R00EJ

Meritor Wabco Vehicle Control Systems has advised Blue Bird Body Company that a condition exist in the Meritor WABCO Phase 1 D-version of their hydraulic ABS electronic control unit which does not comply with Federal Motor Vehicle Safety Standard (FMVSS) 105.

Recall R00EJ WABCO ECU Noncompliance Replacement Instructions

PHOTO 1

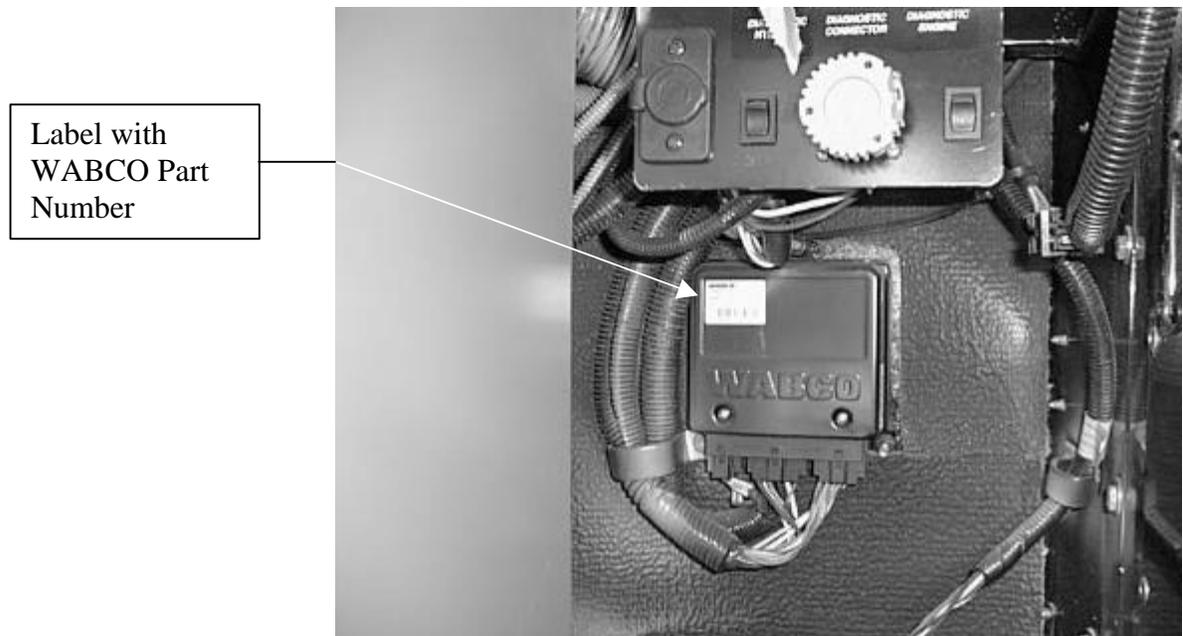
The WABCO ECU is located below the dash on the left inside front wall (see photo 1).

To do this, depress the locking tab located at the top of each harness connector to loosen, then pull the connector loose. DO NOT pull on the wires when disconnecting the harness. **Figure 1.**

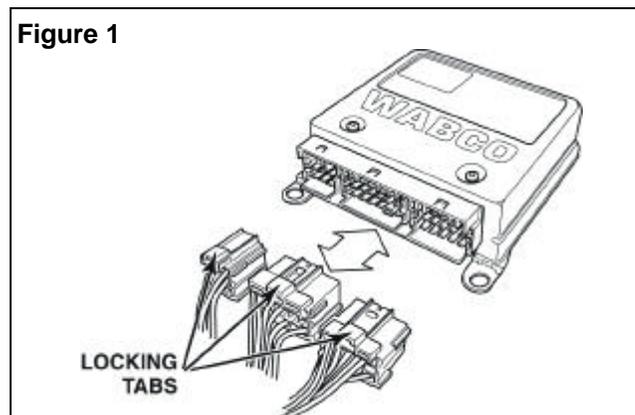
1. Disconnect the negative battery terminal.
2. Locate the ABS ECU.
3. Disconnect the 9-pin, 15-pin and 18-pin harness connectors from the ECU.
